**FW: Submission – Development Application A006923355 – 76 Queens Road, Everton Park**

**FORMAL SUBMISSION / OBJECTION**  
**Development Application – 76 Queens Road, Everton Park (MCU – Multiple Dwellings)**

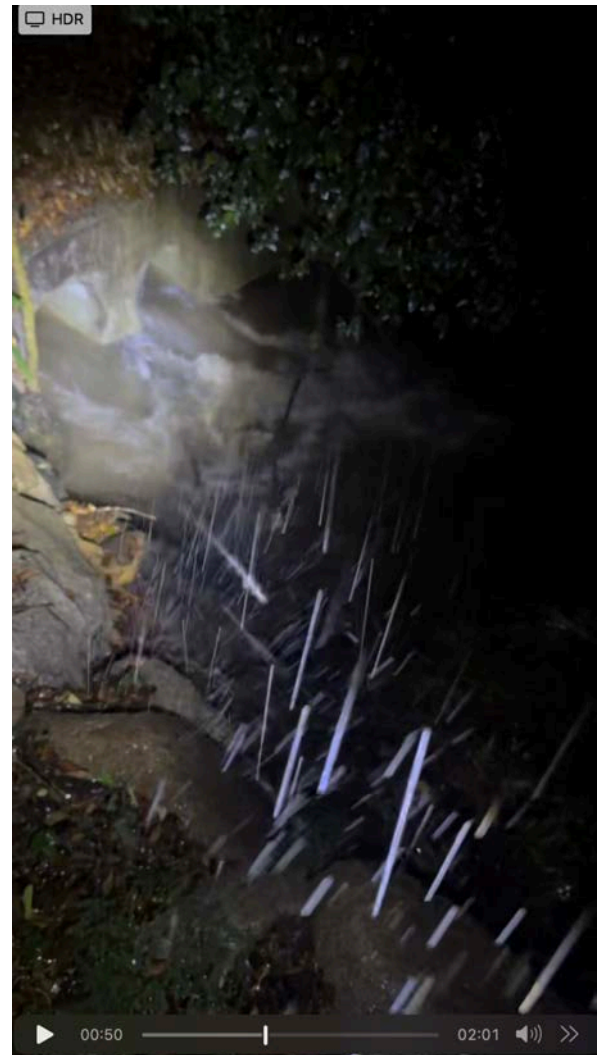
Attached video evidence demonstrates the volume and movement of water through this corridor during **normal heavy rainfall events (not flood conditions)**.

- the intensity of flow through the area
- the reliance on existing vegetation for stability
- the sensitivity of the corridor to disturbance

Any degradation or removal of vegetation will significantly increase risks of:

- erosion
- sediment movement
- weed invasion
- downstream impacts to adjoining properties

Video 3: Our property overland flow

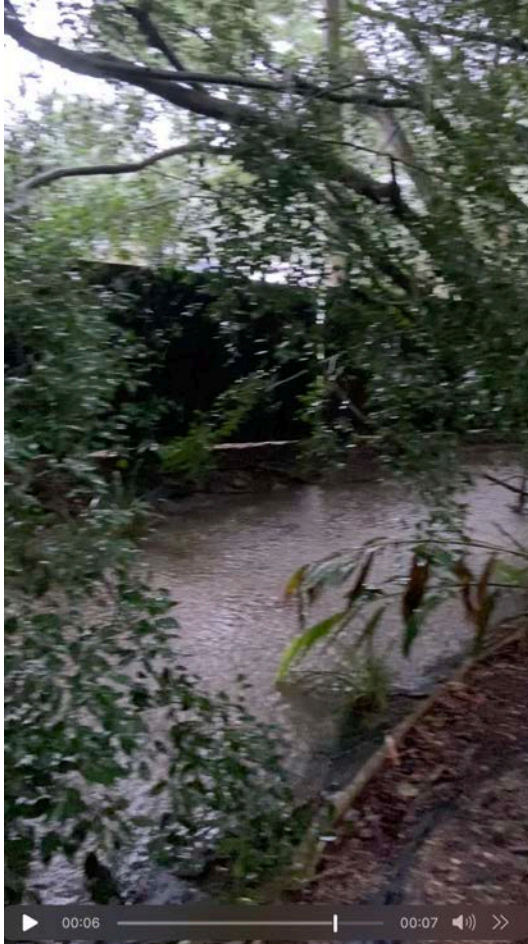
*Attached home videos from recent heavy rain (not flood events) showing the wetland area – screenshots below, full videos provided in submission*

- *Video 1: Vegetation Area*
- *Video 2: heavy overland flow*
- *Video 3: Overland flow from our property*
- *Video 4: Catchment area water passing through development site*
